APPEAL SUMMARY

Appeal ID: 16552

Project Address: 820 N Killingsworth St

Building/Business Name: Kanjay Building

4 3RD FLOOR PROPOSE CODE PLAN
A003
SCALE: 1/8"=1'-0"
ID: A-filename

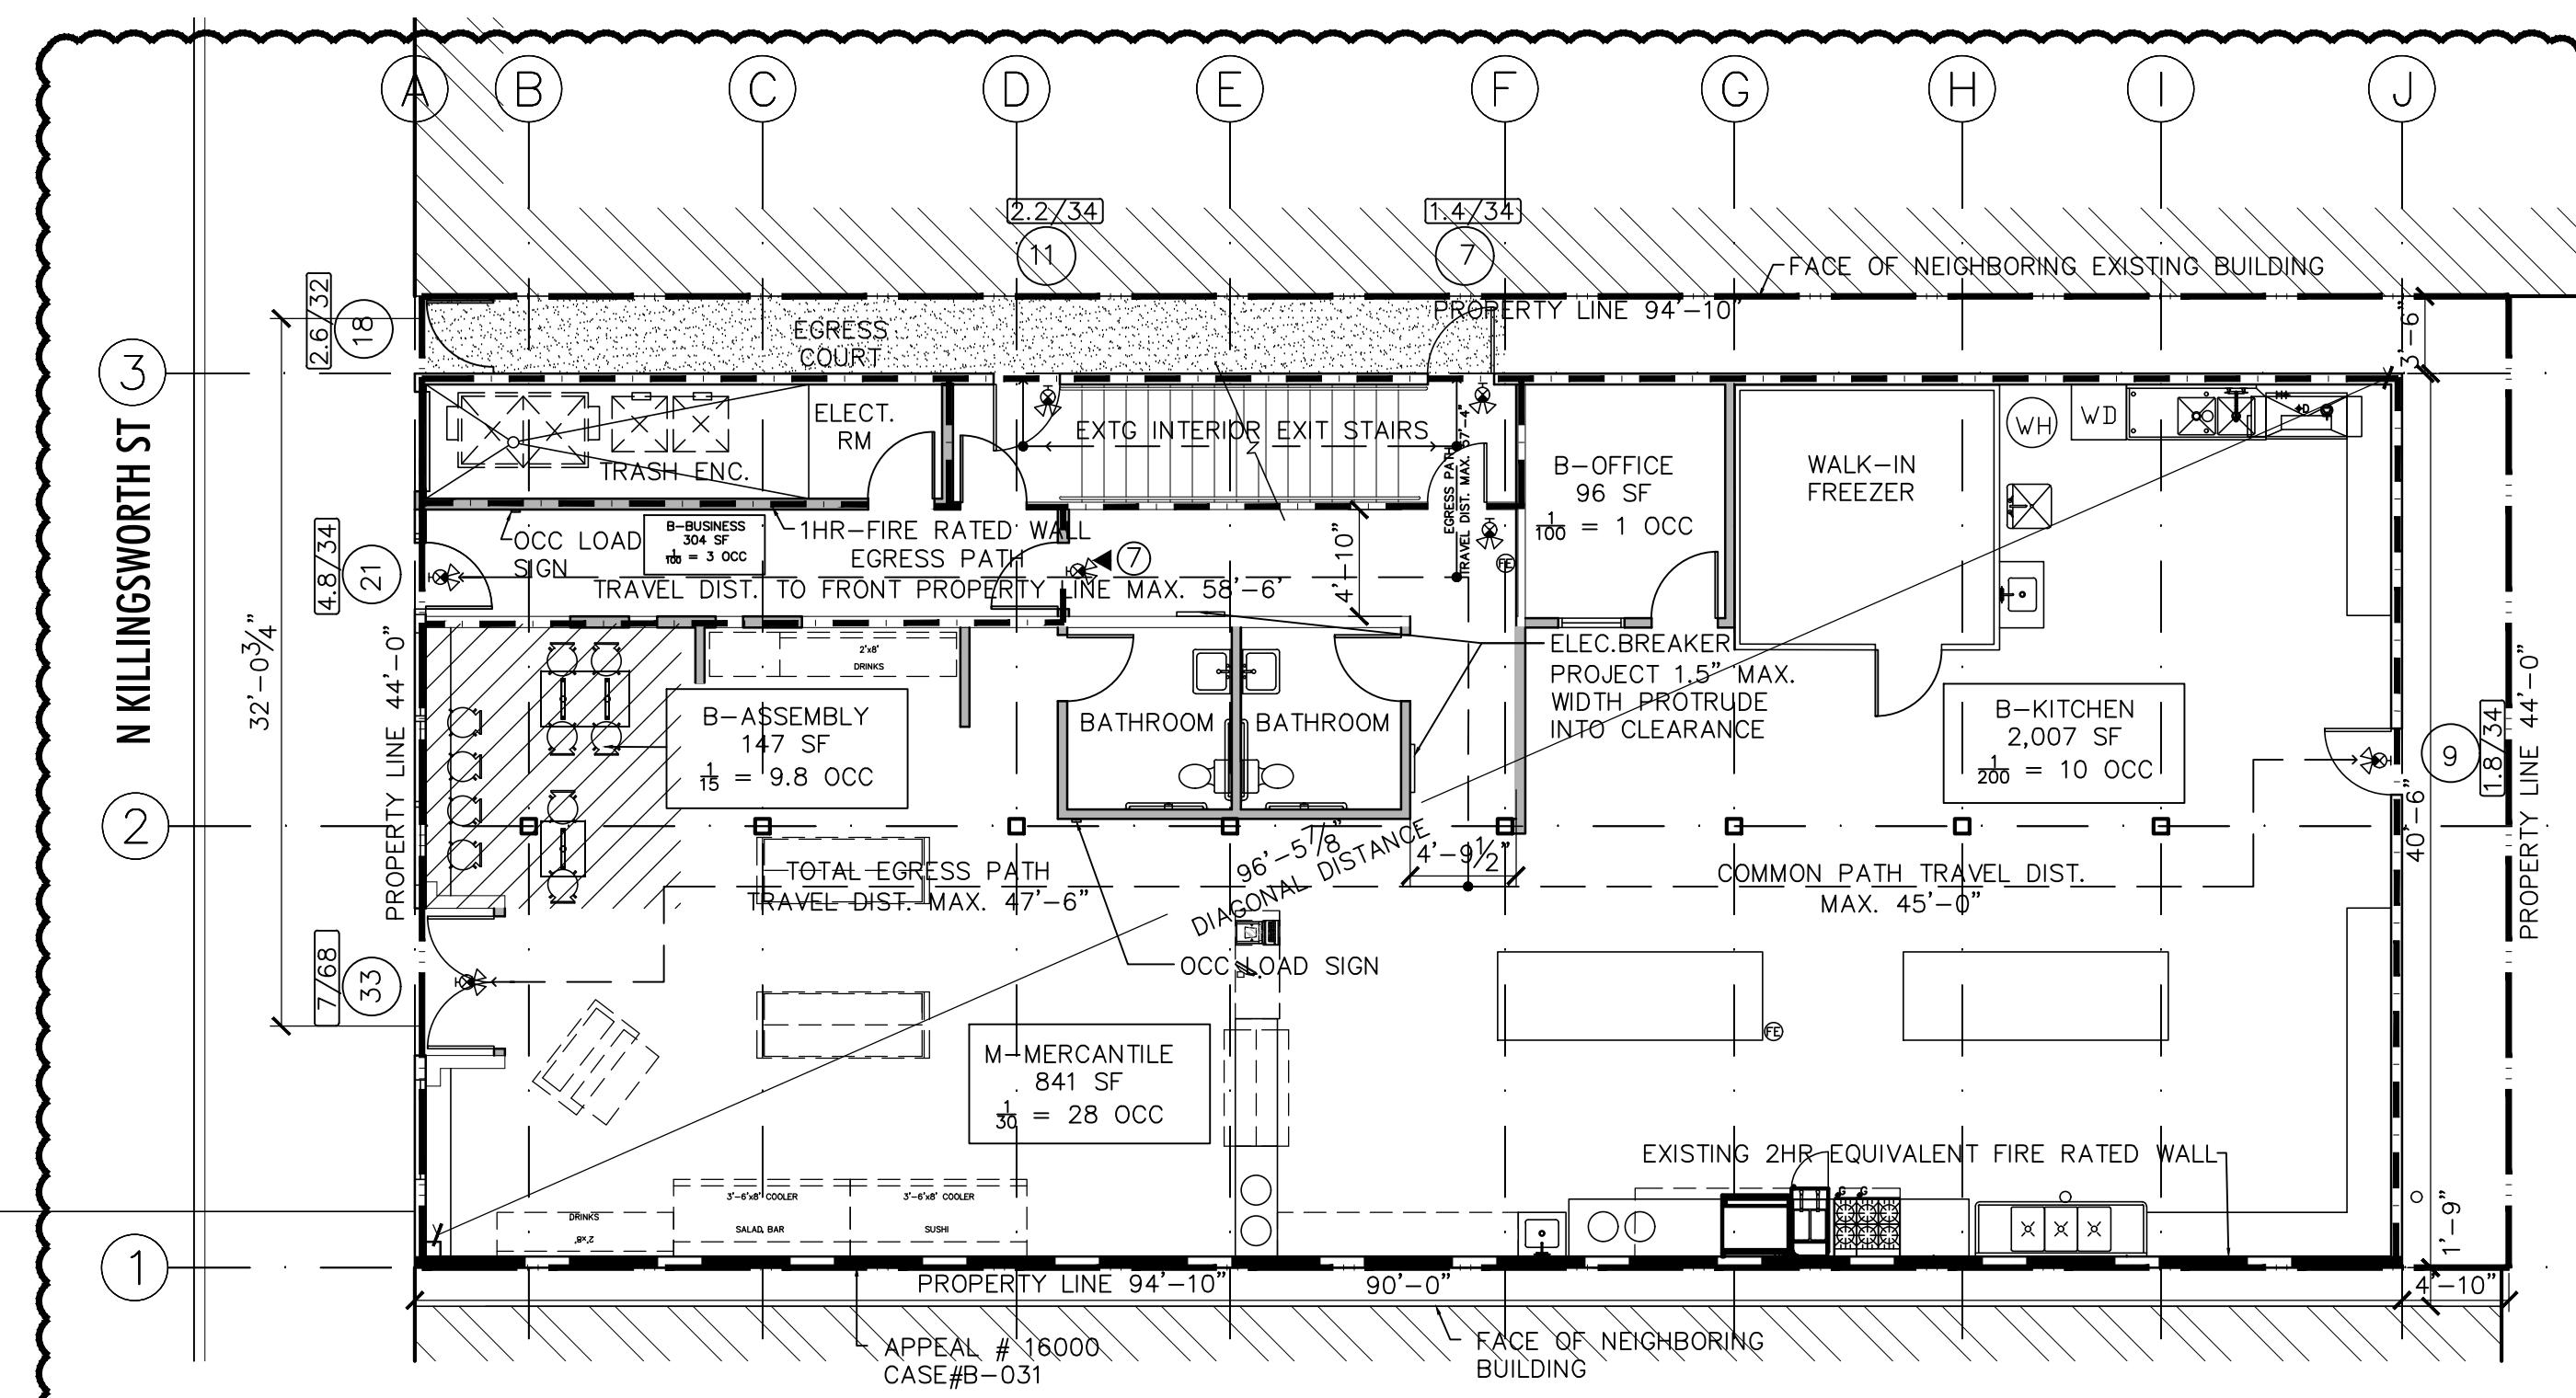
To relieve the building from the chapter 13 mandate and to bring the building into current compliance, we are providing 4 units a floor and updating the existing stair enclosure to an internal exit stair with access from a corridor system, we will sprinkler the building and provide appeals (appeal #16000)and updates for exterior property line walls and separation, this will bring the building into compliance with a 3-story residential occupancy with 1 exit.

We are proposing that the stair rise and run of 7.5" and 13" run be allowed to remain per chapter 34 and that the existing stairs remain in place while protecting the stairs in a code approved shaft. The existing stair width is above adequate, and the railing and guardrail will be brought to current code conformance. This gives equivalent protection to the stair and enclosures while allowing us

The current building condition and type does not comply with the current code without a sprinkler system. The building and height don't work with the VB designation that is the current stated building type. With sprinklers the building would be allowed under the type VB separated uses, with 4 units the building code would allow one exit. With sprinklers and a protected stair, the egress length is brought to current code.

Having the occupancy updated to have a code allowed single egress in a protected shaft increases safety over the current open stair enclosure and fire escape egress. Currently multiple rooms egress over the adjacent roof of the neighboring property. That condition would be alleviated by reducing the unit number and creating bedrooms that face egress windows. Interior wall ratings and corridor ratings for fire protection would be brought up to current code and current UL listings.

1. Removal from Chapter 13 status: Hold for additional information.

STAIRS 1HR RATED, TYP.
A301
SCALE: 1"=1'-0"
ID: A-Filename

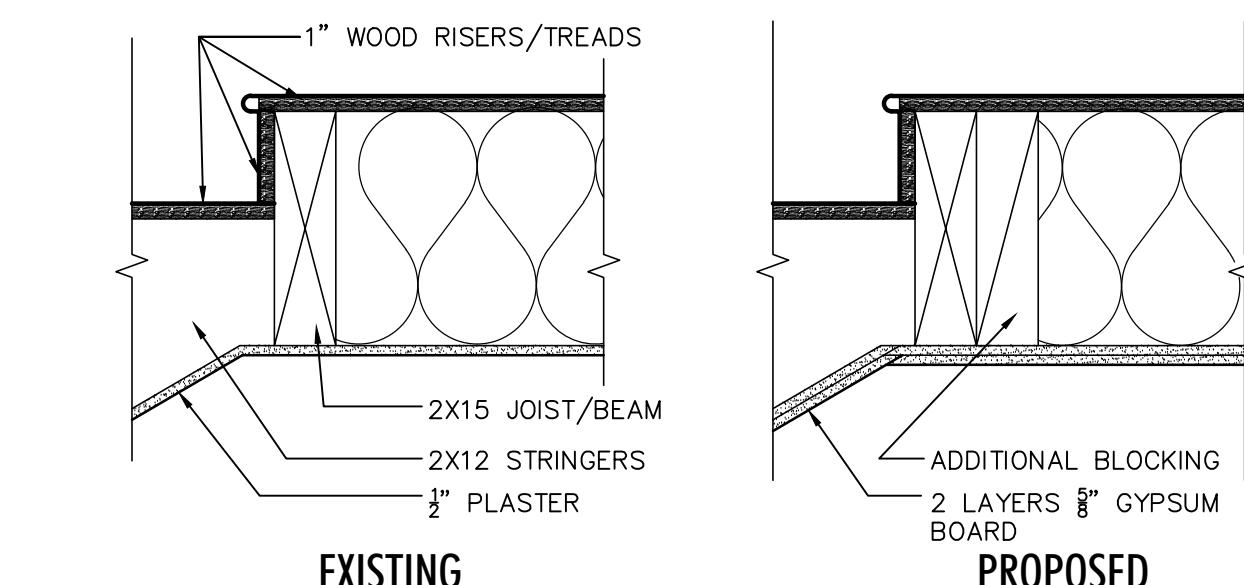
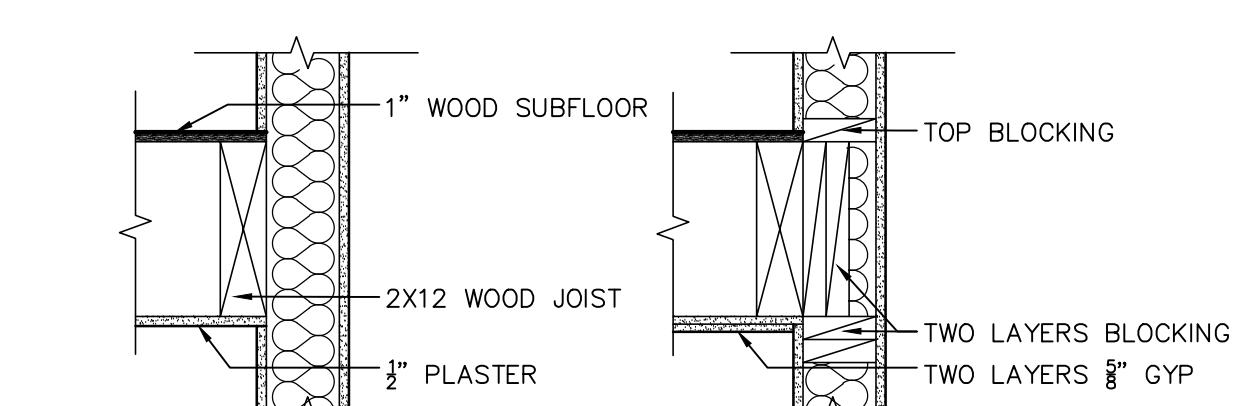
1. PROVIDE TWO LAYER OF GYPSUM BOARD UNDERSIDE OF EXISTING STAIRS STRUCTURE, TWO LAYERS OF BLOCKING AT LEDGERS, JOISTS, BEAMS AND DOUBLE PLATE AT INTERMEDIATE LANDINGS.
